Access Compliance Report Public Rights-of-Way (Curb Ramps)

Intersection ID: 10033071 Main Street: NORTH_COMMUNITY_HOUSE_RDss Street: N/A Location: NW

ADA ID: 677DCD48DA39 Ramp Type: Perp Initial Pass/Fail: Fail Overall Compliance: No Severity Score: 13.75

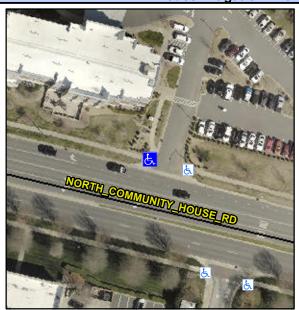
Possible Solutions:	<u>c</u>		
Remove & Replace Entire Ramp.			
·	Υ		
	N		
	N		
	N		
	N		
Surveyor Notes:	N		
N/A	N		
	N		
	N		
	N		
PROW/ADA:	N		
Not Found, R304.2.2, R304.5.3	N		
	N		
	N		
	N

Comp	liance Description	Data	Comp	liance Description	Data
N/A	Ramp Length (in)	59.0	No	Ramp Slope (%)	9.7
Yes	Ramp Width (in)	48.0	No	Ramp XSlope (%)	3.6
N/A	Flare Type LT	N/A	N/A	Flare Type RT	N/A
N/A	Flare Slope LT (%)	N/A	N/A	Flare Slope RT (%)	N/A
N/A	Flare Traversable LT?	N/A	N/A	Flare Traversable RT?	N/A
N/A	Landing Length (in)	N/A	N/A	DWS Provided?	N/A
N/A	Landing Width (in)	N/A	N/A	DWS Contrast?	N/A
N/A	Landing Slope (%)	N/A	N/A	DWS Length (in)	N/A
N/A	Landing X Slope (%)	N/A	N/A	DWS Full Width?	N/A
N/A	Landing Curb? (Y/N)	N/A	N/A	DWS Offset (in)	N/A
N/A	Shared Landing?	N/A			
N/A	Gutter Ponding?	N/A	N/A	Gutter Slope (%)	N/A
N/A	Gutter Lip Ht (in)	N/A	N/A	Gutter X Slope (%)	N/A
N/A	Painted X Walk1?	No	N/A	Painted X Walk2?	N/A
	X Walk 1 Direction	To SE		X Walk 2 Direction	N/A
N/A	X Walk 1 Width (in)	N/A	N/A	X Walk 2 Width (in)	N/A
	X Walk 1 Slope (%)	3.5		X Walk 2 Slope (%)	N/A
	X Walk 1 X Slope (%)	0.0		X Walk 2 X Slope (%)	N/A
